Detailed Site Plan Walker Mill Self-Storage

DSP-23012

STAFF REPORT

SUBJECT: Detailed Site Plan DSP-23012
Type 2 Tree Conservation Plan TCP2-027-2020-01
Walker Mill Self-Storage

Figure 1: Site Plan

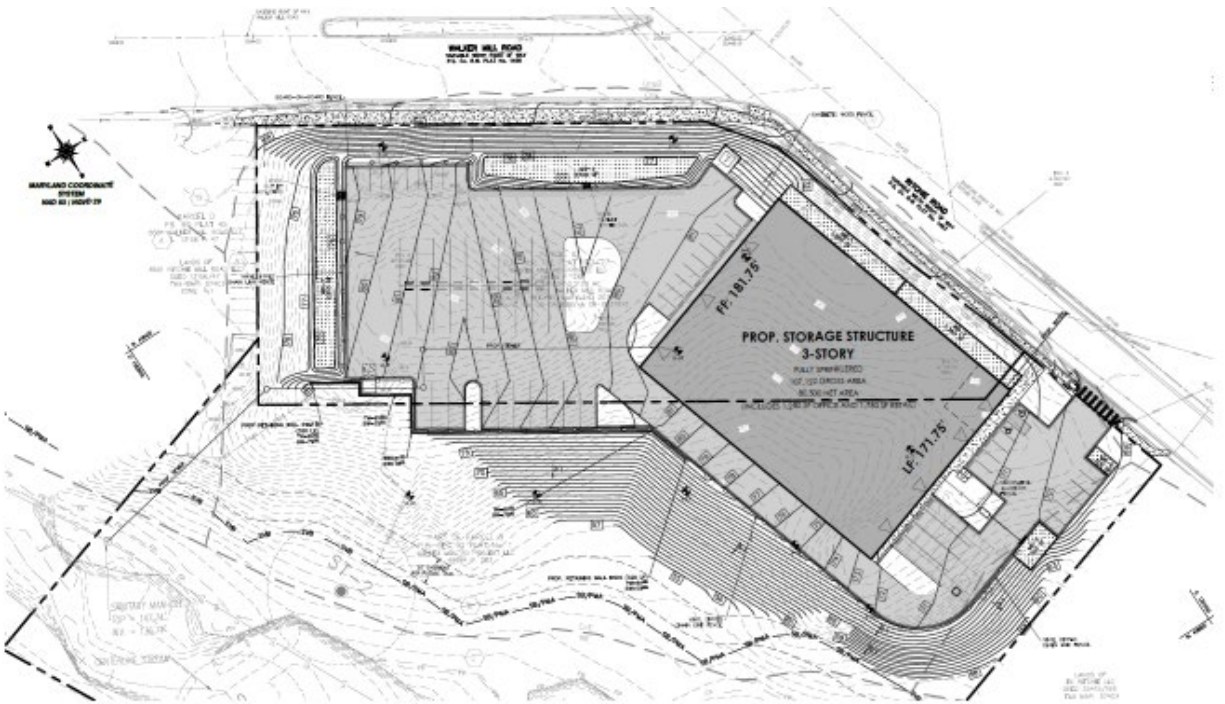
Note: *There is a discrepancy in the provided green area. A condition is included herein requiring the applicant to correct this number.

The site has one proposed entry/exit point along Walker Mill Road. Vehicular access to the rear of the site is gate controlled to limit access beyond the secured area. Two truck turning exhibits were also provided to demonstrate the ability for large vehicles to maneuver through the site. Sidewalk connections and a crosswalk are provided along the Walker Mill Road and Ritchie Road frontage. A crosswalk for pedestrians is provided in the rear parking area of the site, to facilitate movement through the parking lot. These designated pedestrian areas will separate the interaction between pedestrians and motorists.

- b. Correct the applicant's name on the coversheet.
 - c. Correct the total percentage of the provided green area.
 - d. Correct General Note 28 since the subject site is located within the prior Military Installation Overlay (M-I-O) Zone.

- a. Revise the number of shrubs in Schedule 4.2-1.
 - b. Correct the abbreviation of shrubs, *Pruns Laurocerasus*, for consistency.
 - c. Label Parking Lot A and Parking Lot B on the plans.
